⌘ **25.427 CR 102** ⌘ rev  ⌘ Current version: **6.1.0** ⌘

<b>Title:</b>	⌘ E-DCH Frame format update		
<b>Source:</b>	⌘ Nokia		
<b>Work item code:</b>	⌘ EDCH-lurlub	<b>Date:</b>	⌘ 09/03/2005
<b>Category:</b>	⌘ <b>F</b>	<b>Release:</b>	⌘ Rel-6
	<i>Use <u>one</u> of the following categories:</i> <b>F</b> (correction) <b>A</b> (corresponds to a correction in an earlier release) <b>B</b> (addition of feature), <b>C</b> (functional modification of feature) <b>D</b> (editorial modification) Detailed explanations of the above categories can be found in 3GPP <a href="#">TR 21.900</a> .		<i>Use <u>one</u> of the following releases:</i> <b>Ph2</b> (GSM Phase 2) <b>R96</b> (Release 1996) <b>R97</b> (Release 1997) <b>R98</b> (Release 1998) <b>R99</b> (Release 1999) <b>Rel-4</b> (Release 4) <b>Rel-5</b> (Release 5) <b>Rel-6</b> (Release 6) <b>Rel-7</b> (Release 7)

Figure 11a: E-DCH UL DATA FRAME structure

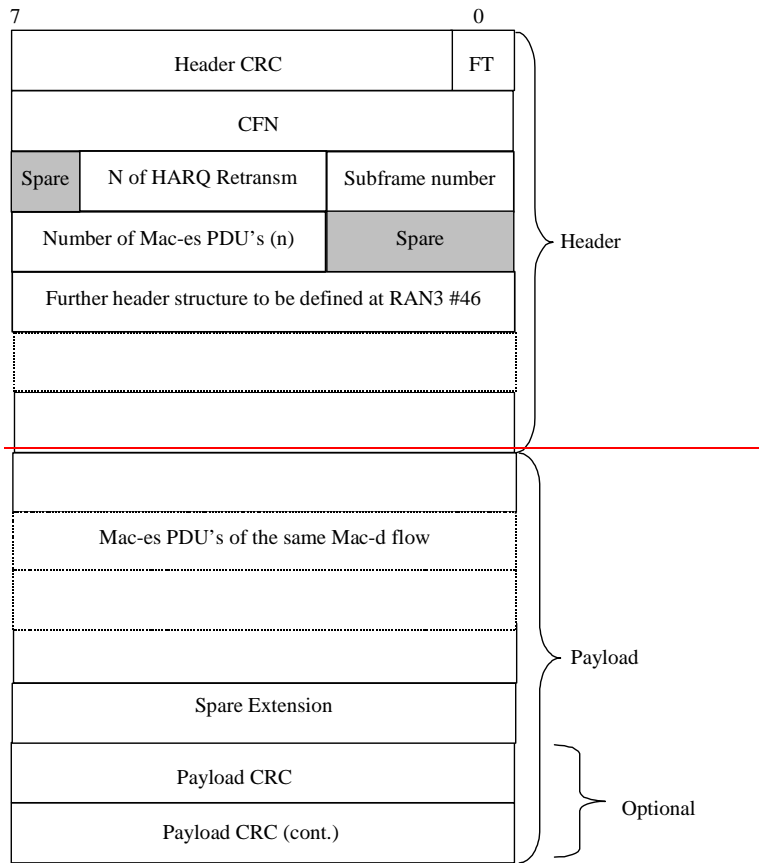
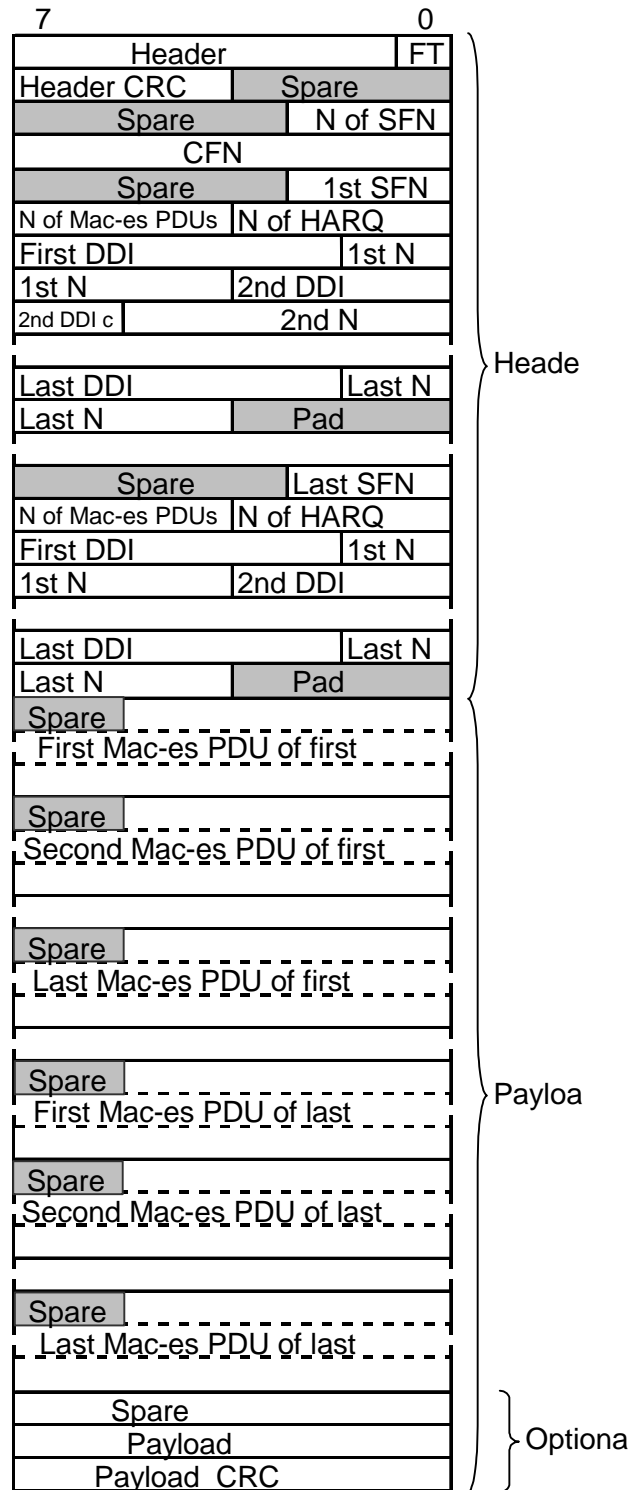
<b>Reason for change:</b>	⌘ Update of the E-DCH Frame format in the lub/lur User Plane Protocol
<b>Summary of change:</b>	⌘ The “padding” field (2 bits) located at the of MAC-es PDUs in the frame payload is changed to “spare” bits as the length of the field is always 2 bits and as it is always included. - The position of spare bits is changed to the beginning of the MAC-es PDU in the frame payload. ----- Update of the E-DCH Frame format
<b>Consequences if not approved:</b>	⌘ The frame payload is not optimal from the processing point of view

[When there is an odd number of DDI + N field pairs for a subframe, then 4 bits padding is used as shown in the figure in order to have the octet aligned structure.](#)

[If a Mac-es PDU does not fill an integer number of octets, then bit padding is used as shown in the figure in order to have the octet aligned structure.](#)
